Re: Abengoa Mojave Solar Project (09-AFC-5): Supplemental Written Response to Data Request Set 1B (nos. 1-86)

Soils and Water Resources (21-61)

Application for Certification for the **ABENGOA**)
MOJAVE SOLAR POWER PLANT)

Figure 43-5. Groundwater elevations at the end of 2012 (end of construction period) with all of the existing wells pumping rates increase by 10% and the Abengoa Solar Energy Project proposed wells pumping at 670 gpm.

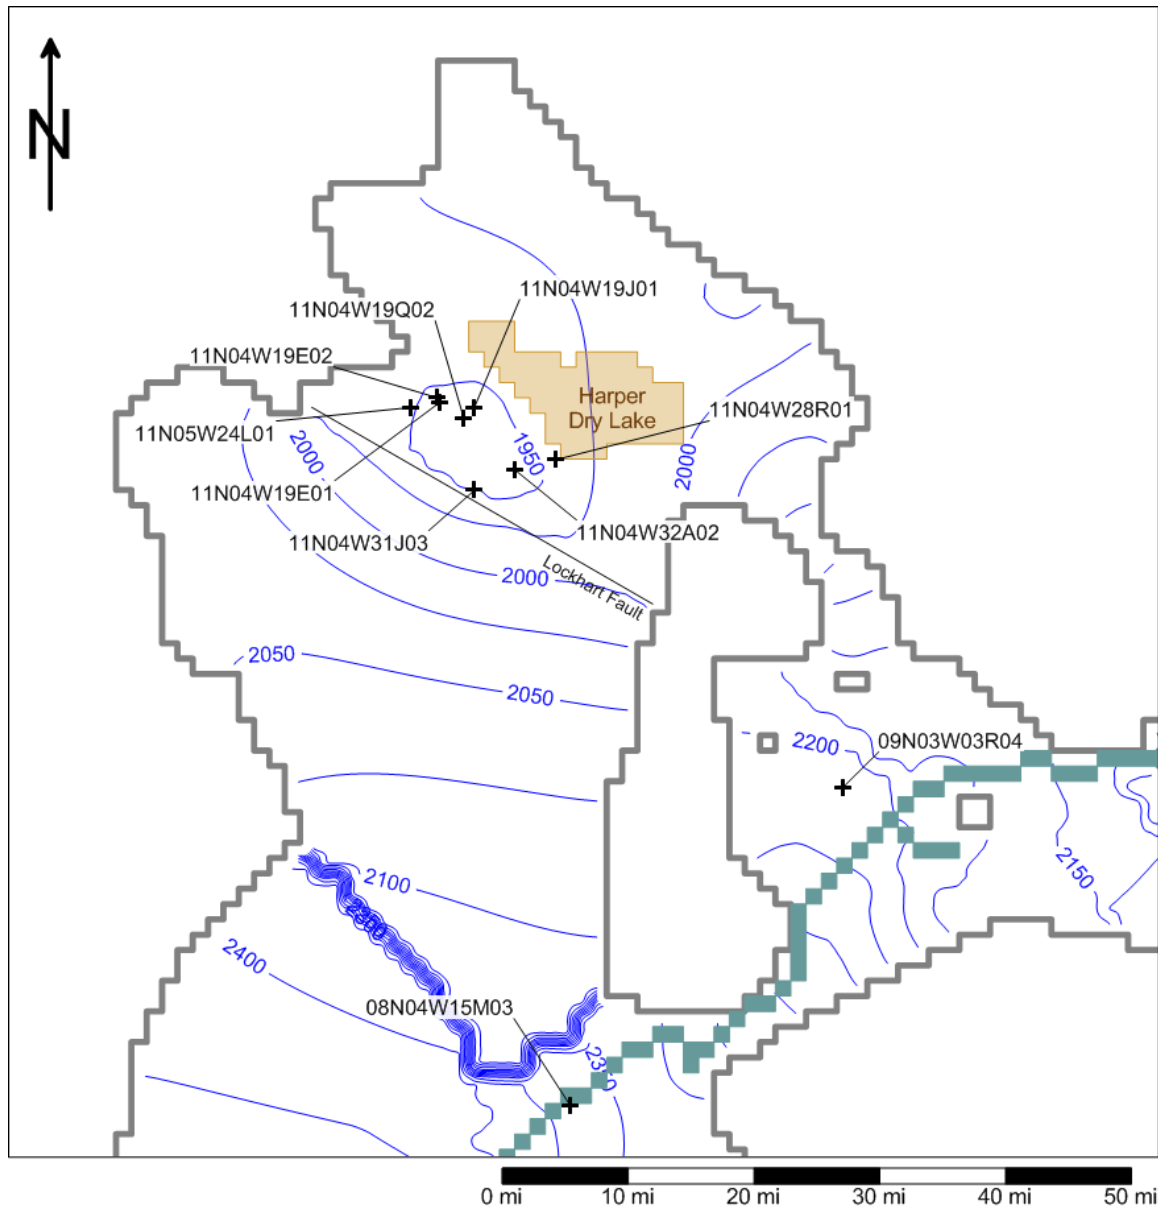
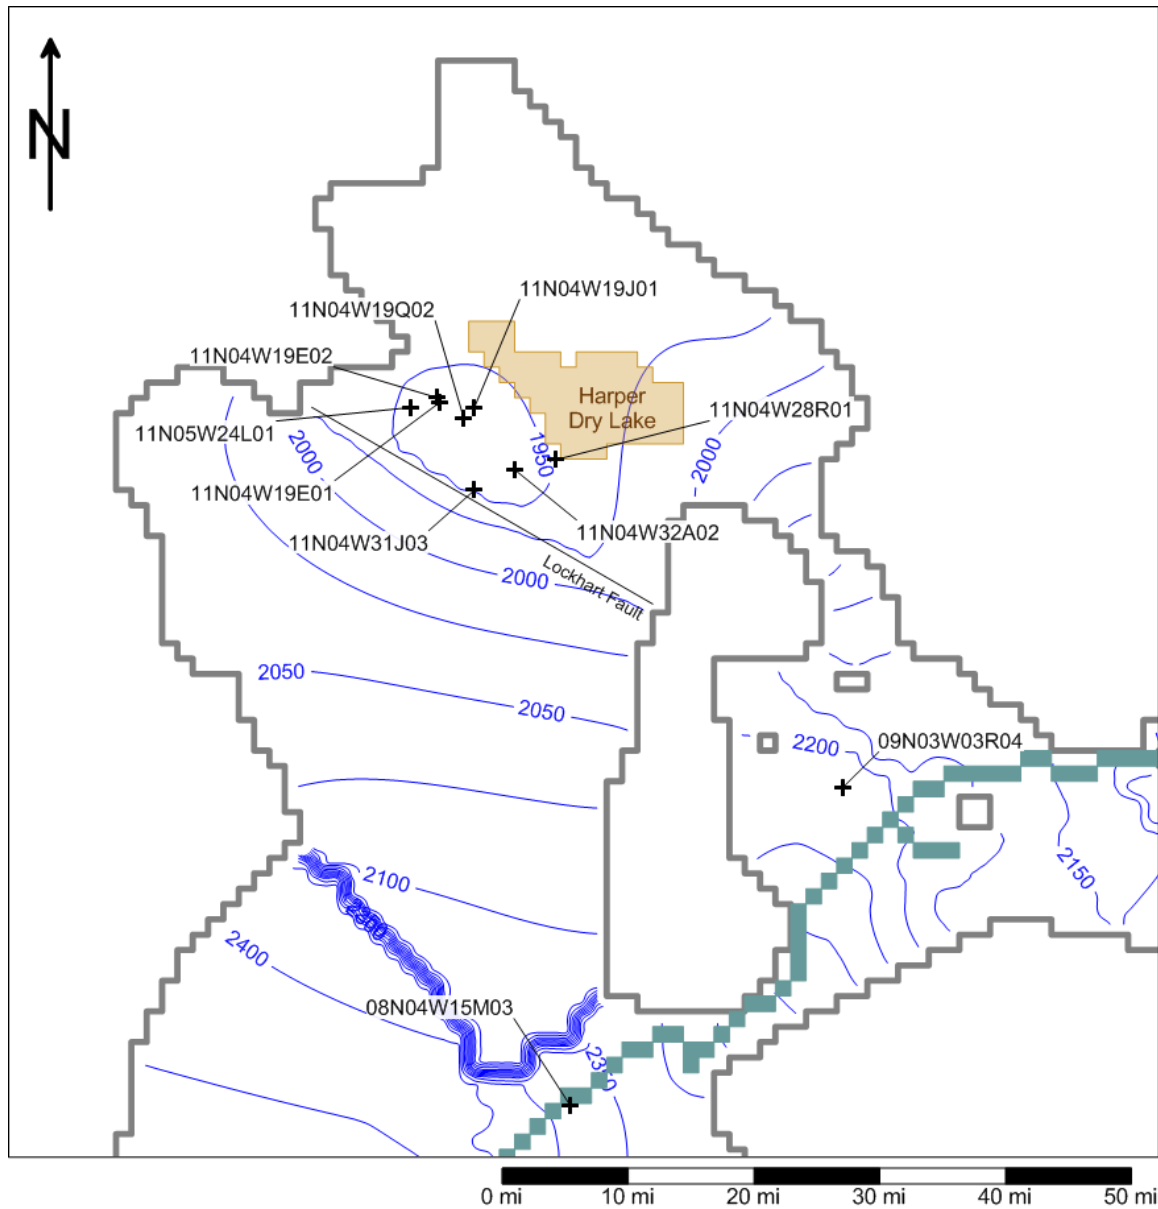
Please provide a table that summarizes the range in simulated impacts at the existing wells tabulated above to represent a plausible range in aquifer property values from previous studies, the literature, and model calibration.

Since the rate of future withdrawals is the most important source of uncertainty for this analysis, we have re-run the model to examine the impact of a 10% increase in pumping within Harper Valley. Figures 41B-2 through 41B-6 and Figures 43-5 and 43-6 illustrate this.
